| Office Action Summary | Application No. 10/076,915 | Applicant(s) TONKOVICH ET AL. | |

DETAILED ACTION

2. Claims 13, 16 and 17 are rejected under 35 U.S.C. 102(b) as being anticipated by Hirsch (US 3,712,595).

In addition, the Examiner asserts that the process of Hirsch meets the language of the claims. See FIG. 2, which has been annotated as follows:

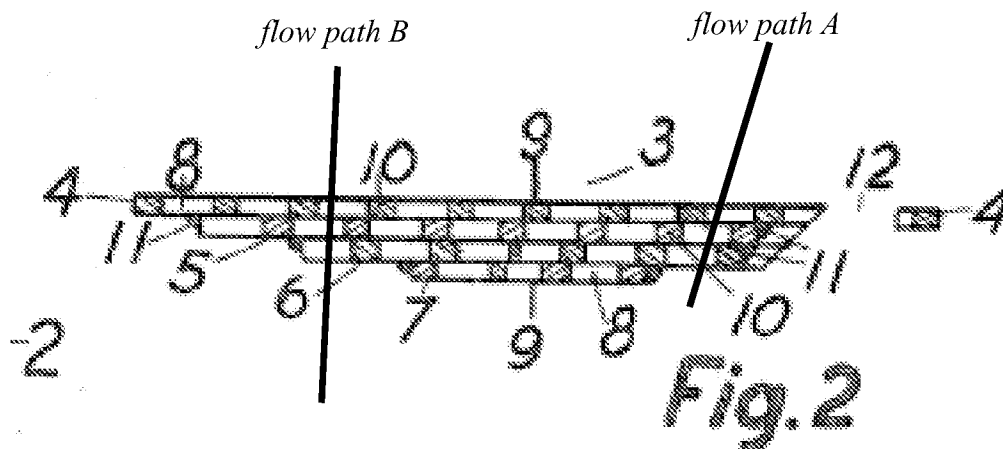
As seen from the figure, for example, the fluid in the flow path A and the fluid in the second flow path B do not mix with one another within the stack of shims (with respect to claim 17).
